ADA Curb Ramp New Construction Inspection Form (Parallel)

Nw 314th ave

24952.54

Nw. Commercial st.

PARALLEL RAMP (PL)

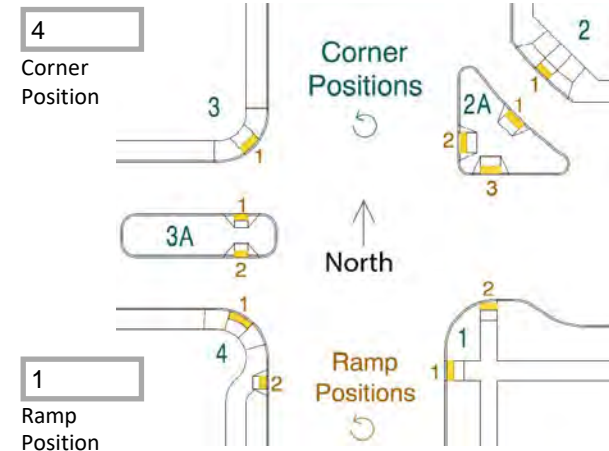
No dome, no RR2, no RR3
